Office Action Summary

10/666,855

WADA ET AL.

DETAILED ACTION***Response to Arguments***

Drawing 1

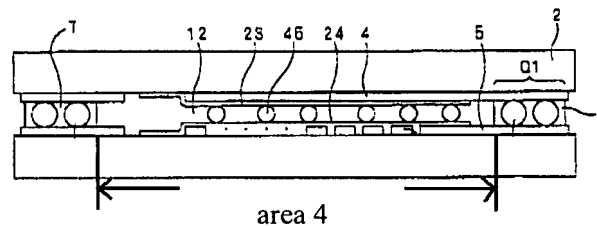
As shown in drawing 1 (which is equivalent to fig. 1a of Asakura) provided below, Asakura teaches intersecting sections at which each wiring line intersects at least one first electrode other than the corresponding electrode.

Drawing 2

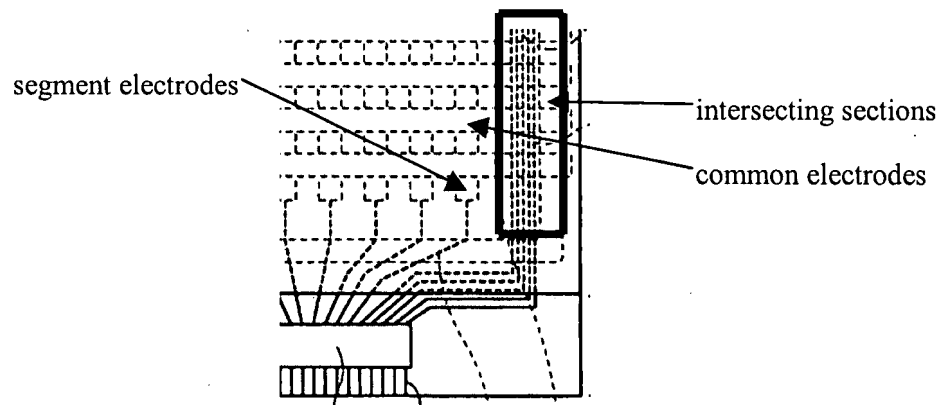
The Applicants argued that, in the device of Asakura, the intersecting area is not in the display area since Asakura refers the area 3 as a display area [Asakura: fig. 2] while the area 3 does not include the intersecting sections. The Applicants further pointed out that the area 4 of Asakura [drawing 2 provided on page 3 of this Office Action, which is equivalent to fig. 2 of Asakura] cannot be referred as a display area since the wiring pattern is provided between the area 3 and the sealing material and thus the area in which the conductor or the connection is formed cannot be a display area.

It is noted that image to be displayed in the device is formed or driven by the voltages applied across the segment electrodes and the common electrodes. In other words, image cannot be formed or displayed in the area where there is no segment electrode or no common electrode. Therefore, if the display area is construed as the area where an image is formed or displayed, the display of the instant Application does not teach the intersecting sections in the display area since the intersecting sections do not include segment electrodes.

Furthermore, since there is no explanation regarding the definition of the display area in the specification of the instant Application, it would be reasonable to refer the area 4 of Asakura [drawing 2 provided on page 3 of this Office Action] as a display area since the area 4 is the entire area inside the
